Delegated Report

Householder Planning Application

Planning Application No: 20220714

Location: Bali-Hai 8 Bycliffe Mews Bycliffe Terrace Gravesend

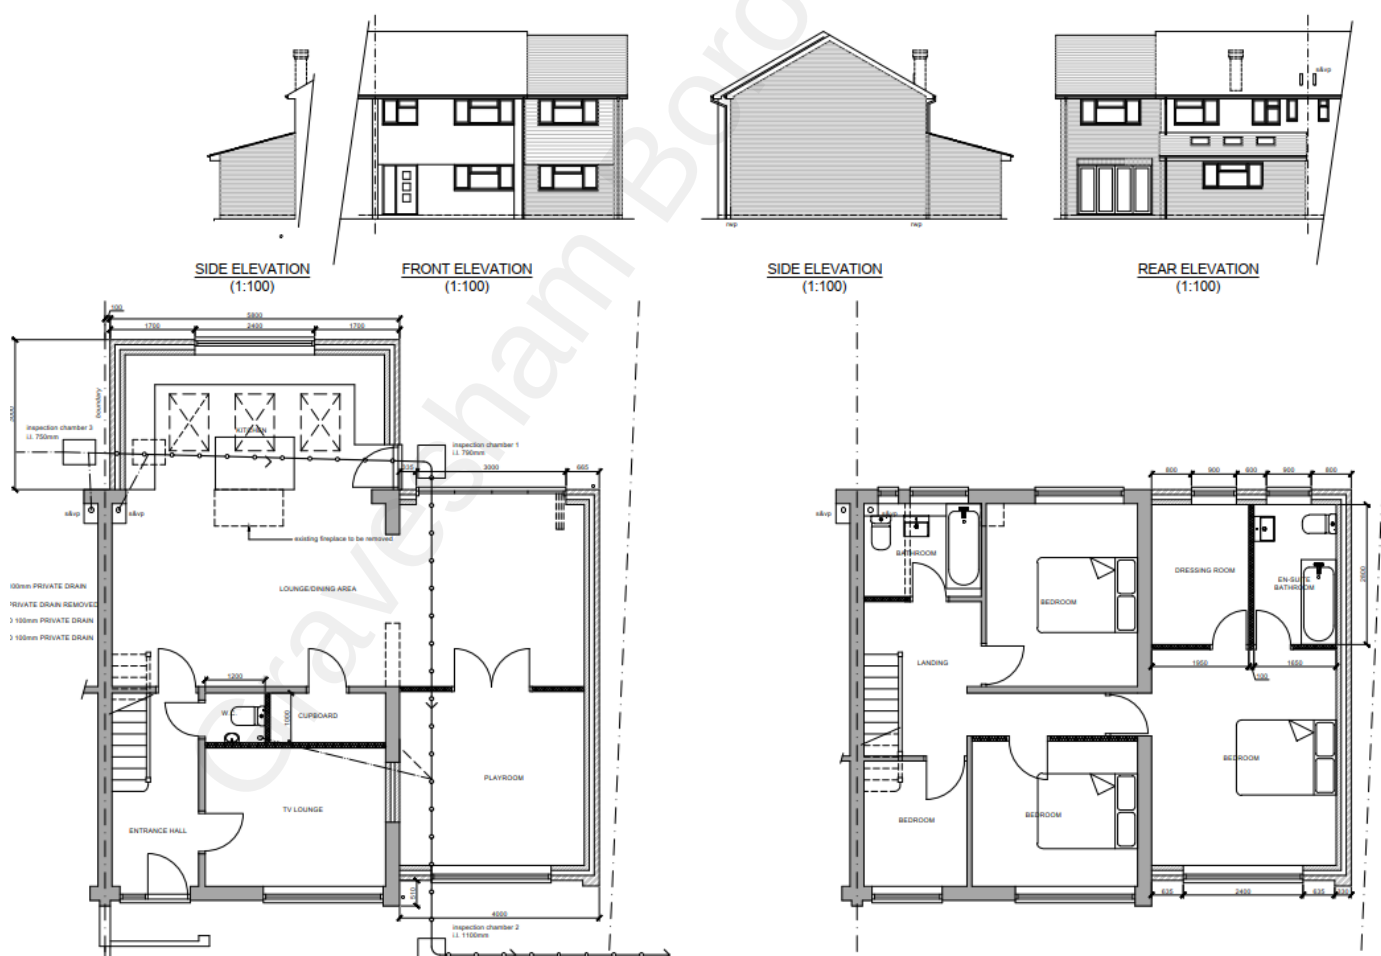
Planning permission was granted for 'Erection of two storey side extension and single storey rear extension' under ref. 20200328.

The approved scheme was as follows:

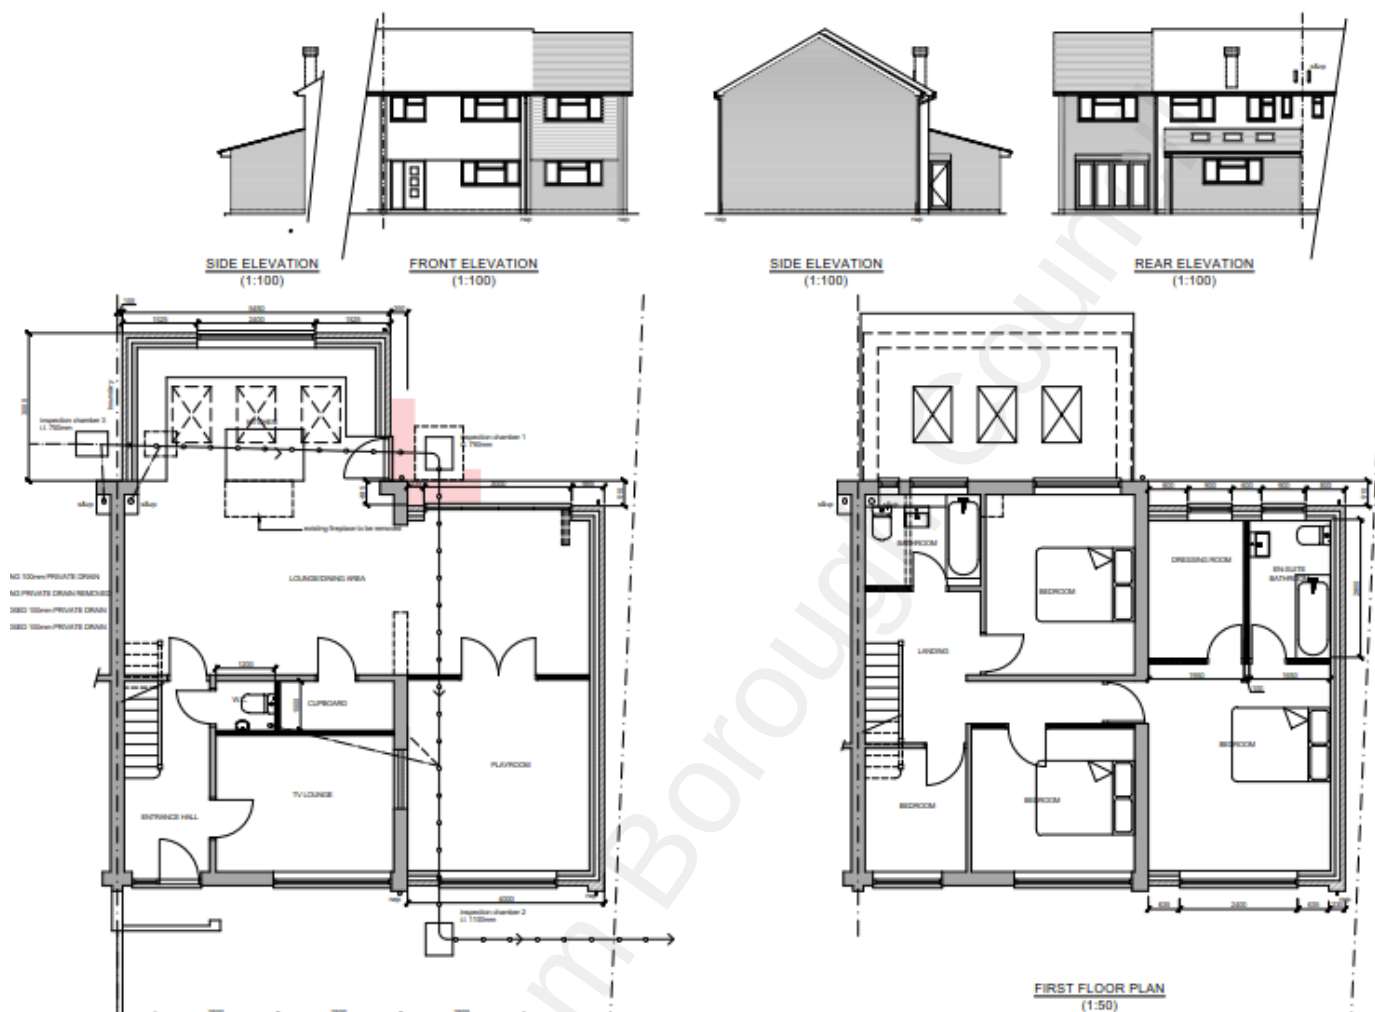
Following this the applicant submitted application ref. 20200392 which was for 'Erection of two storey side

extension and single storey rear extension' and was permitted in June 2020.

The approved scheme was as follows:

The differences being that the rear wall of the extension was set in from the original rear wall of the host dwelling by 510mm to allow necessary clearance from the public sewer inspection chamber 1; the front wall of the extension was also brought in line with the front wall of the host dwelling.

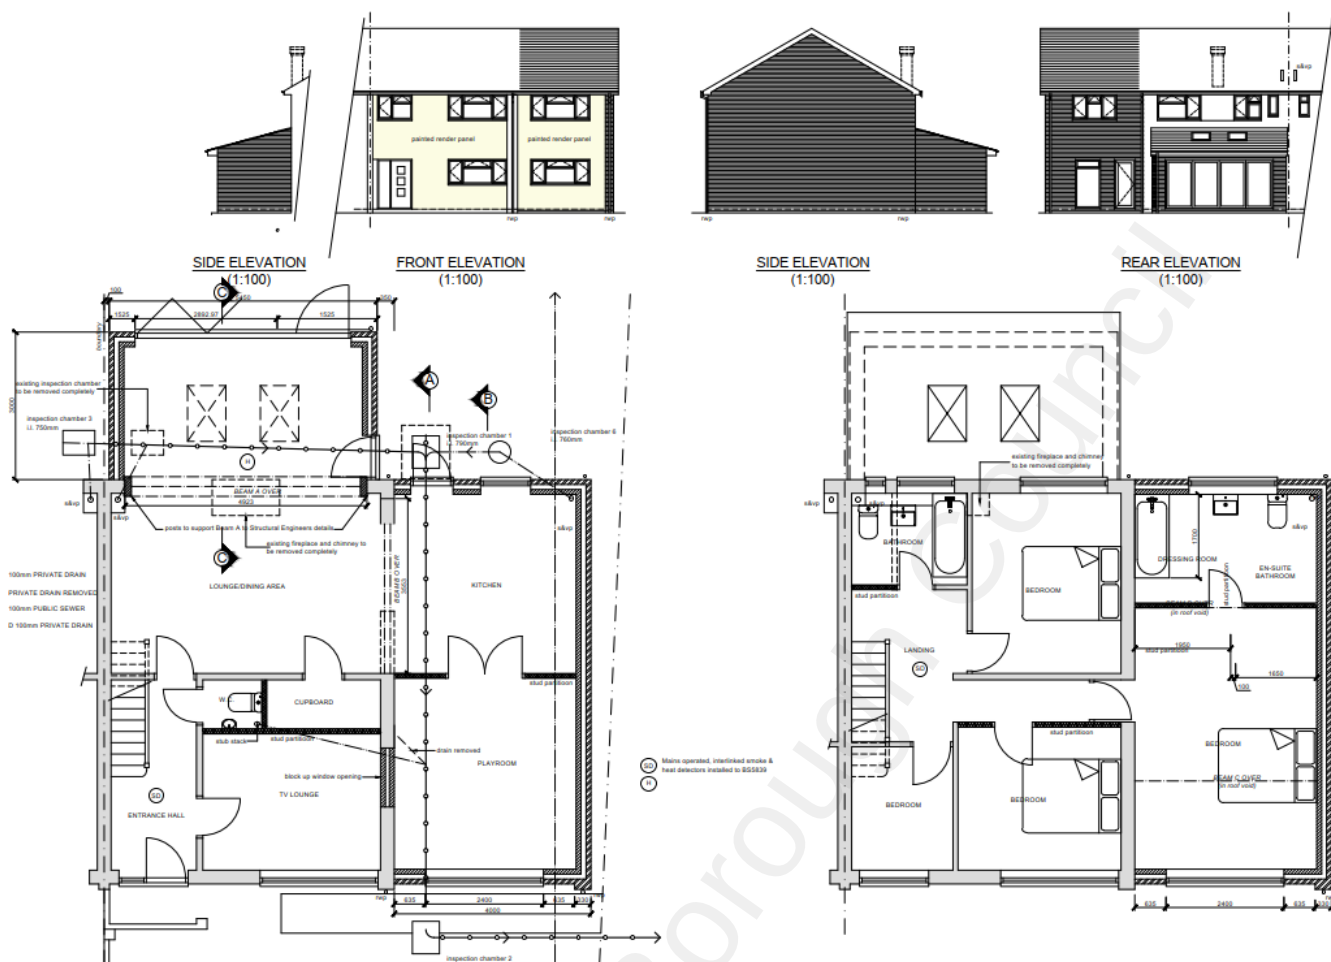
The proposed scheme is as follows:

The changes to the approval as built (and proposed) are:

- The rear wall of the extension has been built in line with the rear wall of the host dwelling and not set in by 510mm;
- The fenestration in the rear elevation has been changed – in the two storey side extension the approved drawing shows bi-fold doors at ground floor level and a window at first floor level in the rear but as built (and proposed) there is now a door and a long window at ground floor and a slightly smaller window at first floor level. In the single storey rear extension the approved drawing showed one window in the rear but as built (and proposed) there are now bi-fold doors.

It is also proposed in this application to face the front elevation with painted render panels in place of the existing brickwork.

The rear wall of the extension being in line with the rear wall of the host dwelling is acceptable in design terms – this is the same as that approved in application ref. 20200328 in which the rear wall of the extension was in line with the rear wall of the host dwelling.

The fenestration changes are considered acceptable, the bi-fold doors have moved from the rear of the two storey side extension to the rear of the single storey side extension and the door and long window are considered acceptable in the rear of the two storey rear extension; being at the rear there would be no

The originally submitted plans shows proposed rendered panels for the front elevation (host dwelling and extension). The agent was advised this would not be acceptable as such a finish would not be in keeping with the streetscene where there are no other buildings in Bycliffe Terrace with rendered frontages and the proposal would not therefore protect the character and appearance of the Pelham Road/The Avenue Conservation Area. The agent was therefore asked to amend the plans to show tile hanging reinstated for the host dwelling and for the extension (the ground floor of the host dwelling and the extension on the front elevation is brick) which is what the main host dwelling previously was (and the adjoining semi no. 7 is); this is therefore acceptable.
